Service Bulletin No.: DAC1-92-08, Rev 0 Date Issued: 09 August 2012

Title: Installation of Illuminated Placards Page: 1 of 5

**2. Effectivity:** DA20-C1 aircraft serial number C0001 thru S/N C0586.

Figure 1 - Exterior Canopy Placards Installation

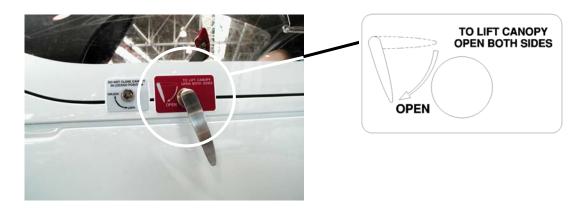
10.1 Replace the following standard English placards with illuminated English placards as shown in Figures 1 through 4. Refer to Aircraft Maintenance Manual DA201-C1 for the instructions to remove and re-install the canopy lock and canopy handles.
